HIGHLINE VILLAGE 4 APARTMENTS
SITE PLAN
LOT 1, BLOCK 1 HIGHLINE VILLAGE 4,
CITY OF AURORA, COUNTY OF ADAMS, STATE OF COLORADO
3.726 ACRES

Highline Village 4
Apartments
Site Plan

COVER SHEET

1 SITE PLAN
SCALE: 1"=20'

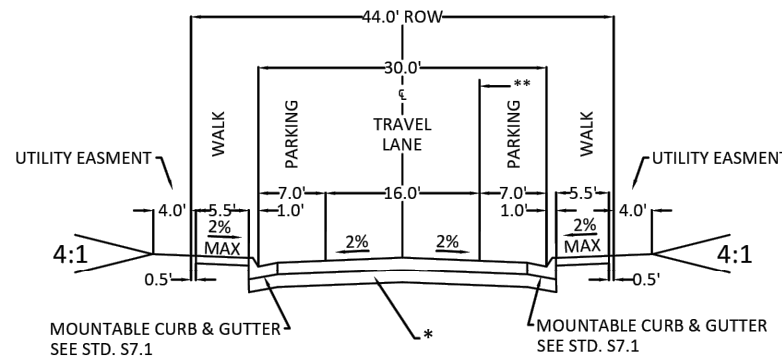
Revised.
Show accessible
route in this area

Remove these lines
and outside turning
radius. They do not
represent the fire
lane easement.
Revised.

Will all of this 30' be
fire lane easement? If
not, please show the
26' section
separately.
Yes, revised.

Please identify third
van accessible
space.

Please add the following note:
"Proposed cross pan locations are
conceptual. Final locations will be
review in the civil plan submittal."

Revised, third space
is identified on the
east side of the
building.

Revised, included in plans.

NORTH &
SOUTH
GARAGE
ELEVATIONS

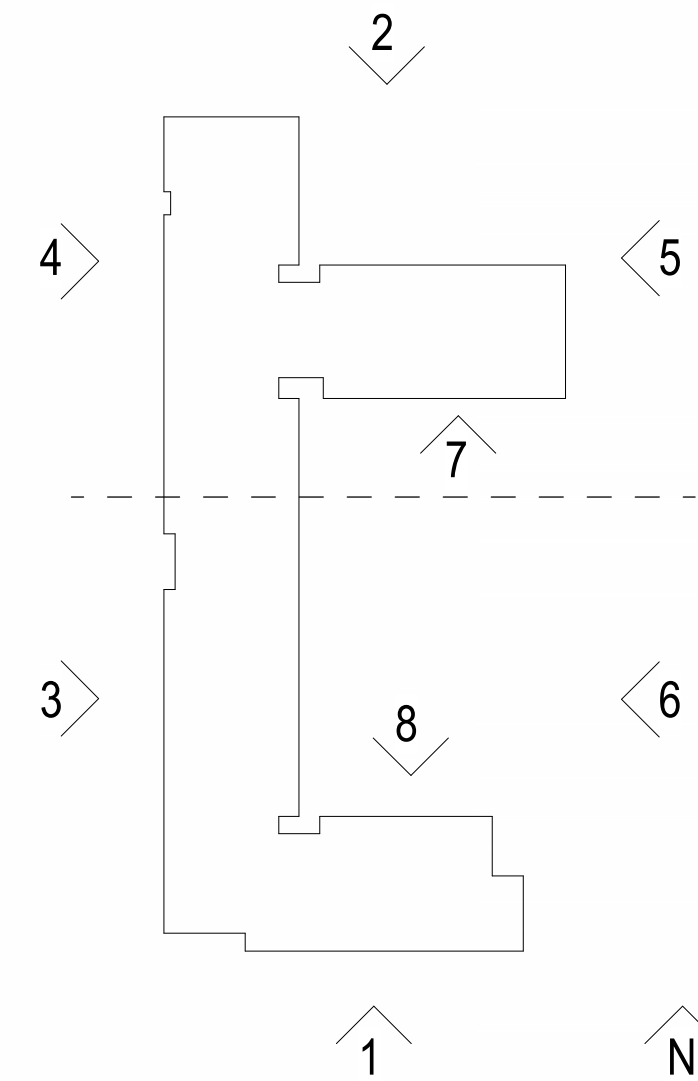
Repeat request. This Knox box location is not consistent with the location shown on other site plan sheets. Please correct.

Revised.

PHOTOMETRIC PLAN

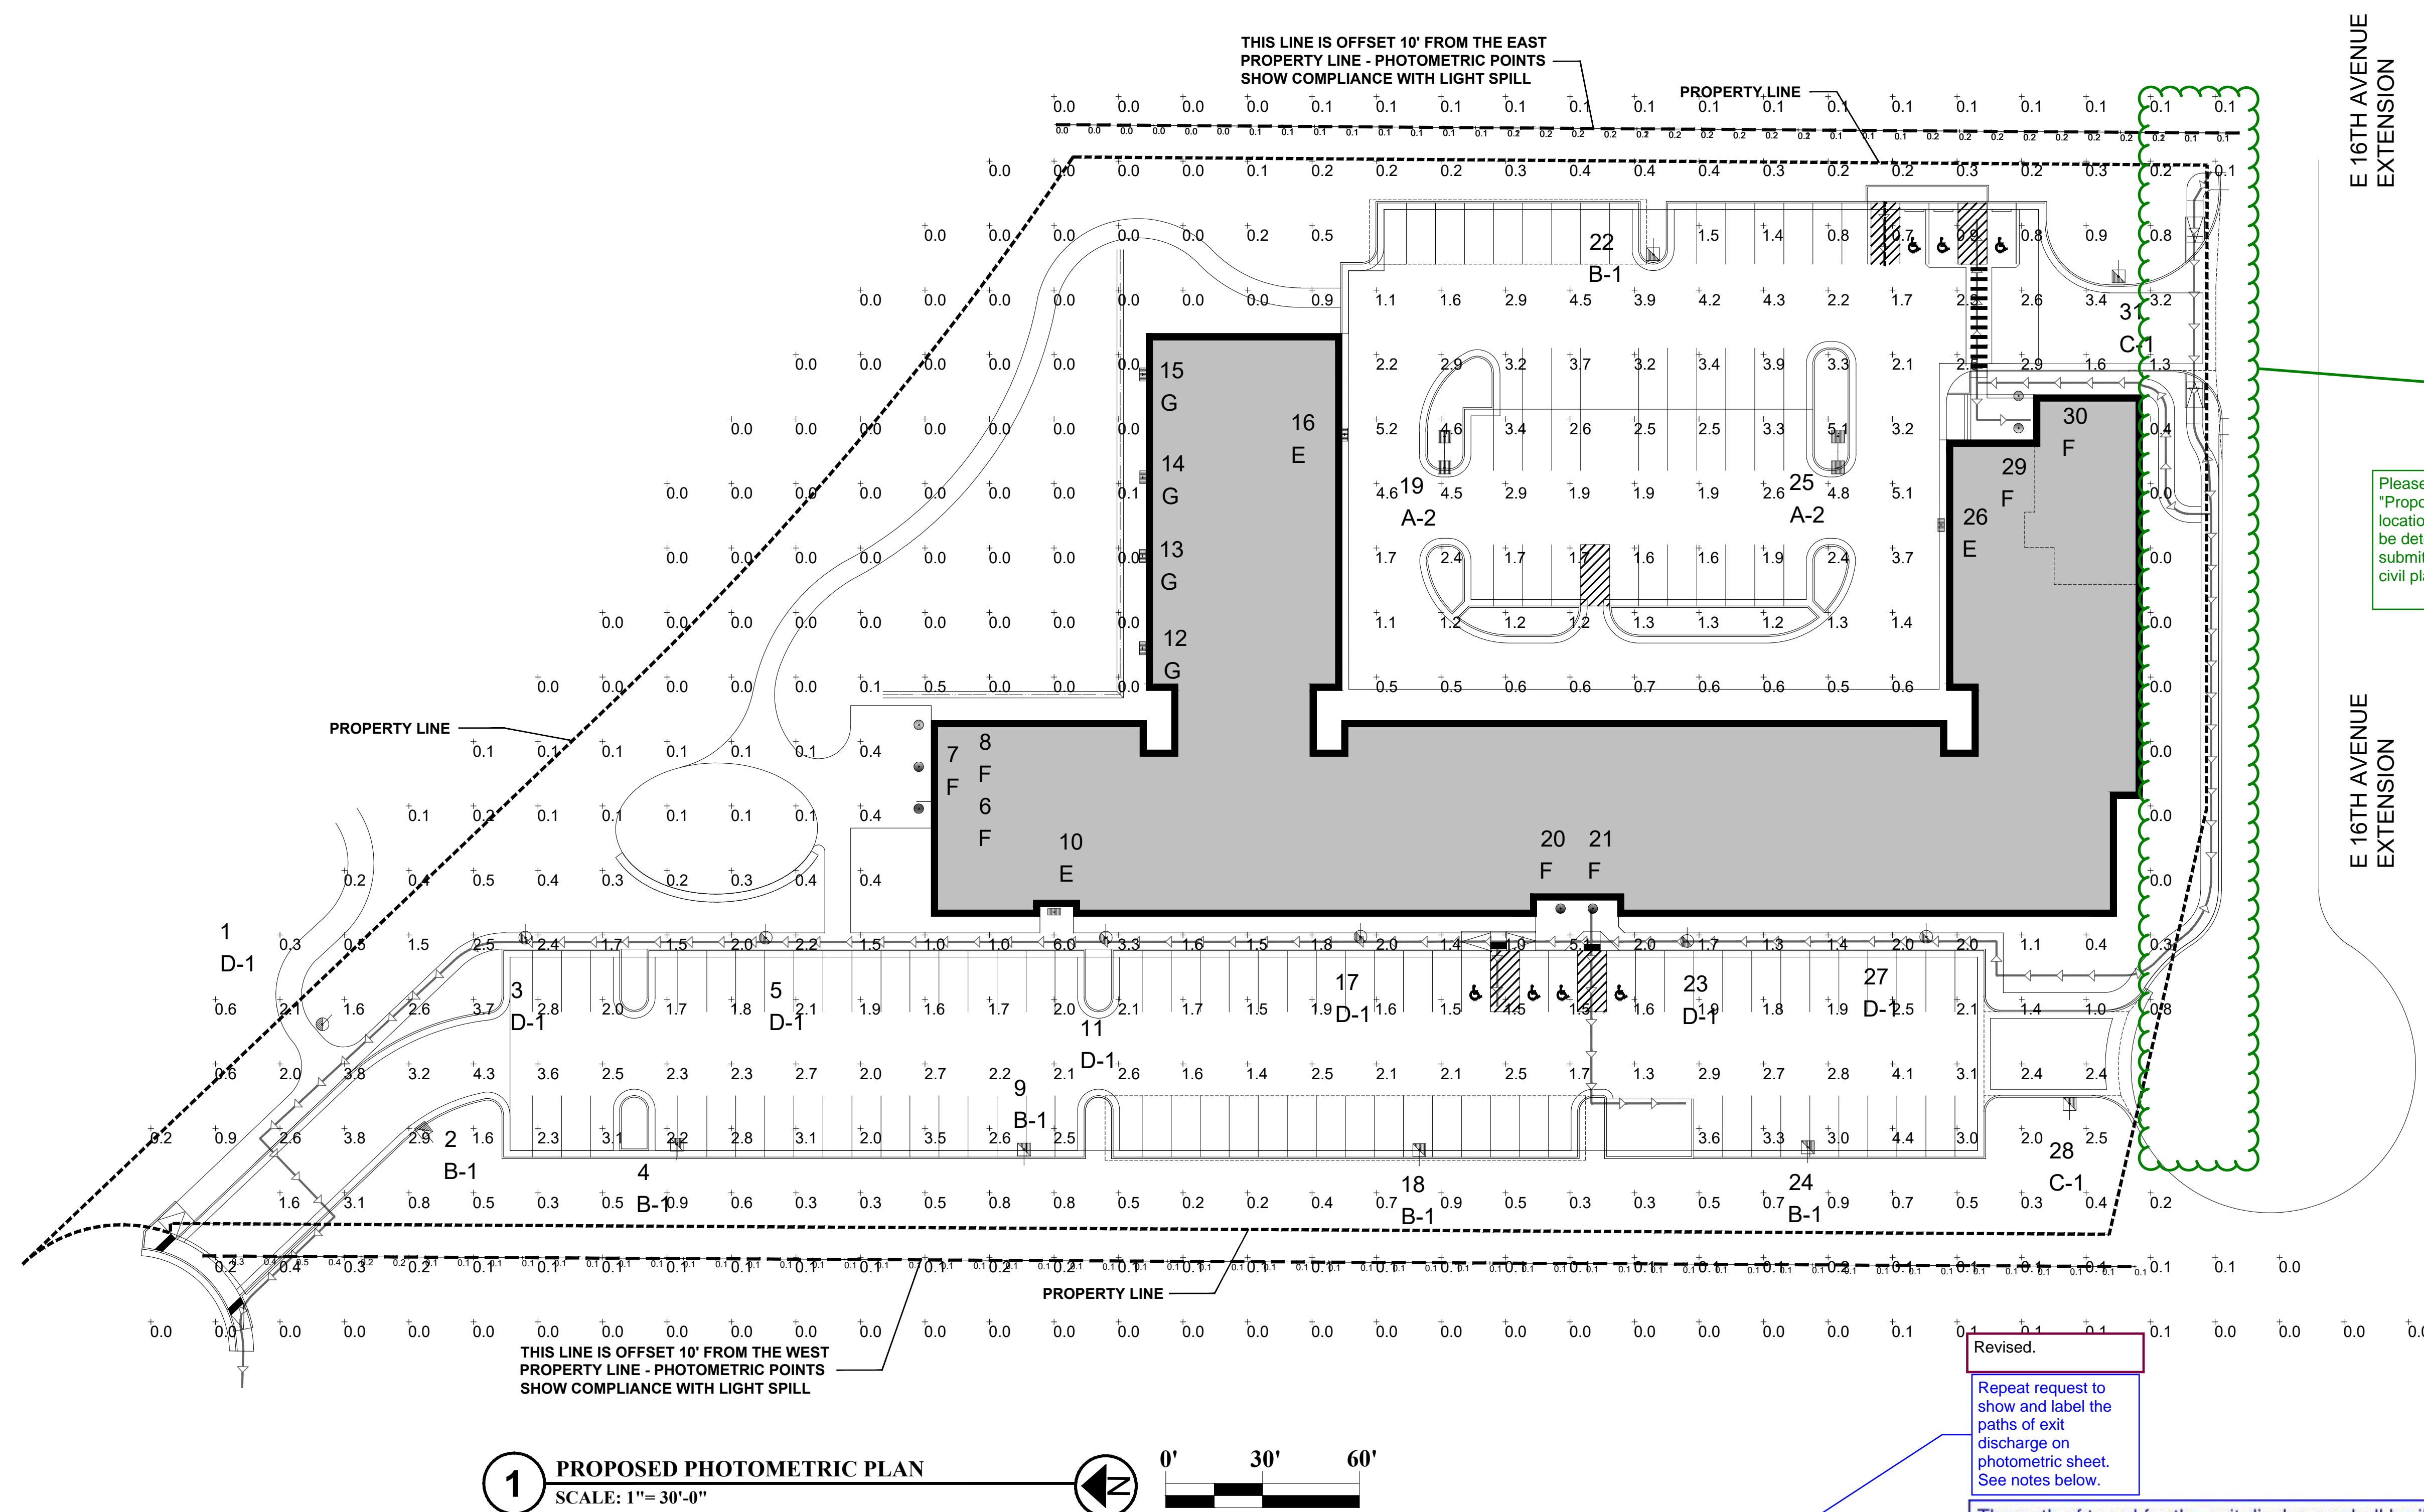
Show the proposed streetlights in the ROW locations, TYF

Please add the following note:
"Proposed street light (in the ROW/Public)
locations are conceptual. Final locations will
be determined with photometric analysis
submitted with the street lighting plans in the
civil plan submittal."

1 PROPOSED LIGHTING PLAN WITH EASEMENTS
SCALE: 1"= 30'-0"

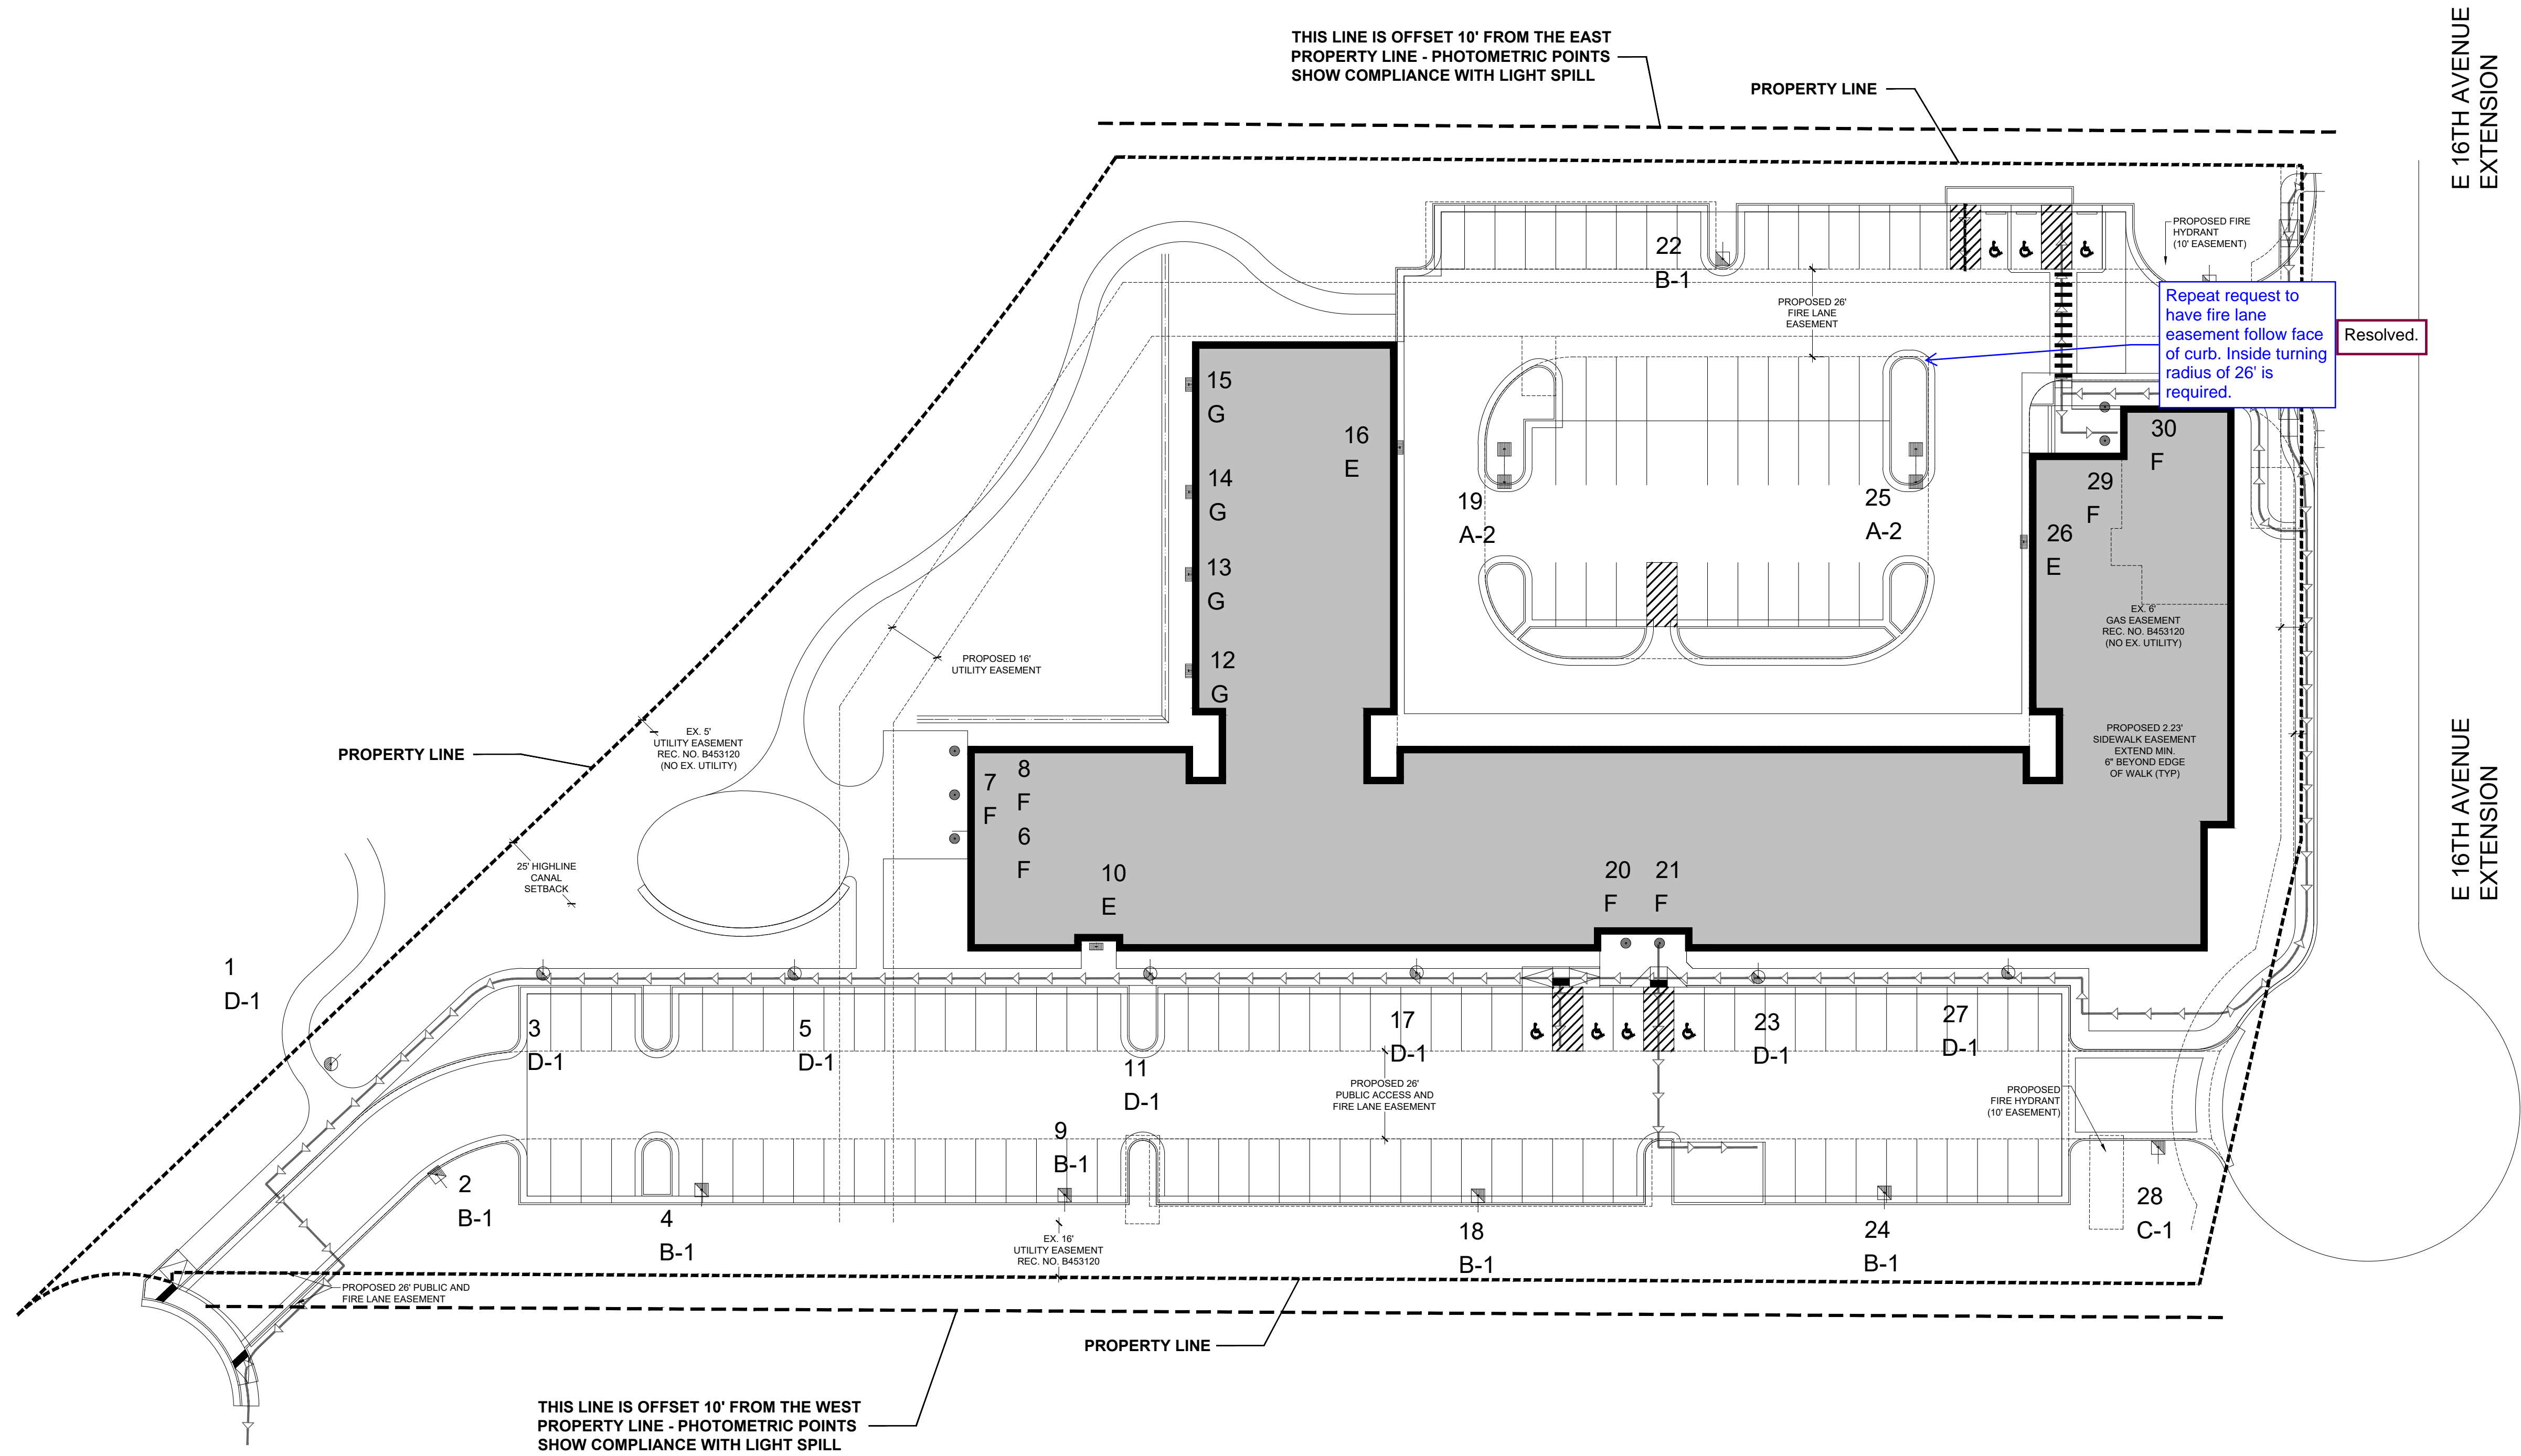
Repeat request to show and label the paths of exit discharge on photometric sheet. See notes below.

Revised
